## Pre-lodgement Meeting Notes

**Application No:** PLM2023/0041  
**Meeting Date:** 20 April 2023  
**Property Address:** 55 Bower Street MANLY  
**Proposal:** Demolition and construction of a dwelling and swimming pool  
**Attendees for Council:** Daniel Milliken (Manager, Development Advisory Services)

*Figure 31 - Side Setback Diagram*

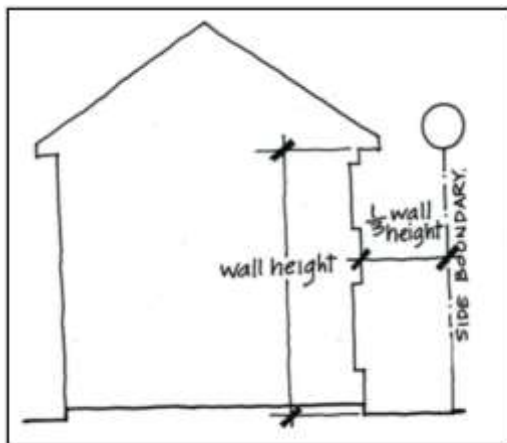
The side setback control under the MDCP, relates directly to the height of the building and the slope of the land. This control associated with the floor space ratio development standard guides the bulk and scale of development. Minimum side setbacks must not be less than one third of the height of the adjacent external wall of the proposed building. Refer to *Figure 31 – Side Setback Diagram* for more information.

The side setbacks proposed for the dwelling appear to provide a dwelling which is articulated and is sensitive to the slope and site constraints of the site. Given the level of detail and information provided, Council cannot determine the minimum numerical controls, however it is evident that the side setbacks proposed will not meet the requirements of the MDCP. As no elevations have been submitted for review, Council is unable to ascertain the extent of non-compliances. Nonetheless, the applicant is advised that the side setbacks should be maximised, by stepping the upper levels back to ensure articulation and modulated wall planes.

The proposed side setbacks should ensure any unreasonable view loss is minimised. As discussed in these Notes, the Applicant is to reduce the height of the development to ensure the dwelling is compliant and does not exceed 8.5m in height.
